Access Compliance Report

Public Rights-of-Way

(Pedestrian Signals)

Intersection ID: N/A	Main Street:	Cross Street: N/A	Location: N/A
ADA ID: A8429DF9DFC8	Signal Type: Two Push Buttons-APS	Overall Compliance: No	Severity Score: BTN 1:N/A BTN 2: N/A No BTN: N/A
Codes/Mitigation Info/Possible Solution		Field Measurements/Component Compliance

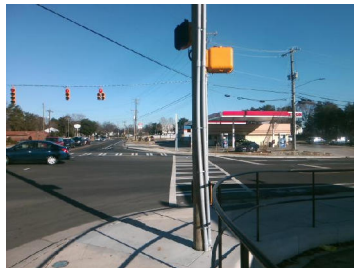
PROW/ADA: TMUTCD 4e.08, R404.2,

Possible Solutions: Replace Signal Push Button With APS Button on New Post. Remove & Relocate Sign.
